Office Action Summary

10/522,890

SUGIOKA ET AL.

DETAILED ACTION

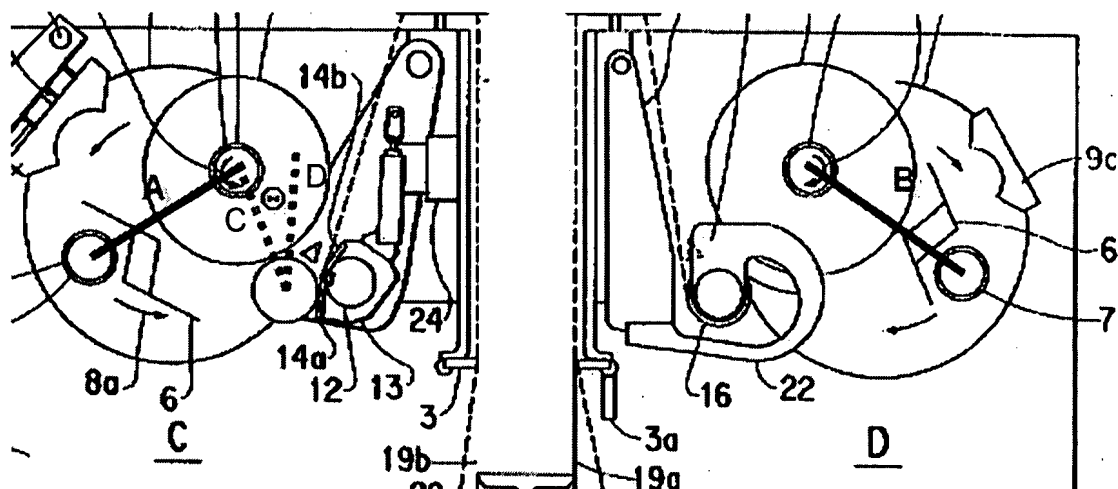
Claims 1-3, 5, 7-10, and 13 are rejected under 35 U.S.C. 102(b) as being anticipated by Daly et al. (US-6015113). Regarding Claim 1, Daly et al. discloses a revolving type winding machine comprising two turret tables C, D having at least two bobbin holders 5a, 5b rotatably mounted thereon, respectively, a press roller 16 and a traverse device 15 are positioned above a horizontal plane in which axes of the at least two bobbin holders lie (Column 5, Line 24-37) upstream from the respective turret table, whereby a bobbin 7 installed on one bobbin holder is switched to a bobbin 7 installed on the other bobbin holder when the yarn wound on the bobbin reaches a predetermined amount characterized in that the two turret tables are disposed on the opposite sides of a yarn passage, rotational directions of a press roller provided for one turret table and a press roller provided for the other turret table are reversed, rotational directions of the one turret table and the other turret table are reversed, and the center of each press roll touching a bobbin holder or a yarn being wound during winding of yarn is located between an imaginary line A (see figure below) passing through the centers of the two bobbin holders projecting from the one turret table and an imaginary line B (see figure below) passing through the centers of two bobbin holders projecting from the other turret table (Figure 1; Column 6, Lines 49-53).

Regarding Claim 2, Daly et al. disclose an imaginary line C (see Figure above) connecting the center of the press roller and the rotating center of the bobbin holder forms an angle Θ which is not larger than 45° relative to a vertical line D (see Figure above) (Figure 1). Regarding Claim 3, Daly et al. disclose the imaginary lines A, B connecting the centers of the respective bobbin holders form "A" shape at least upon start of yarn winding (Figure 1). Regarding Claim 5, Daly et al. disclose that the traverse device 15 is disposed between at least two of the two press rollers (Figure 1). Regarding Claim 7, Daly et al. disclose that the press rollers are moveable so that distance between the centers of the press rollers and the at least two bobbin holders are expanded as the amount of yarn wound on bobbins inserted onto the bobbin holders increase (Figure 1). Regarding Claim 8, Daly et al. disclose the turret tables having the at least two bobbin holders projecting therefrom are moveable so that distance between the centers of the at least two bobbin holders and the press rollers are expanded as the amount of yarn wound on bobbins inserted onto the bobbin holders increase (Figure 1). Regarding Claim 9, Daly et al. disclose the press rollers

are linearly moveable (Figure 1). Regarding Claim 10, Daly et al. disclose the press rollers are rotatably supported at an end of an arm 18, the other end of the arm is pivoted (Figure 1). Regarding Claim 13, Daly et al. disclose the imaginary lines passing through the centers of the respective bobbin holders form an acute angle at their intersect at least upon start of yarn winding (Figure 1).
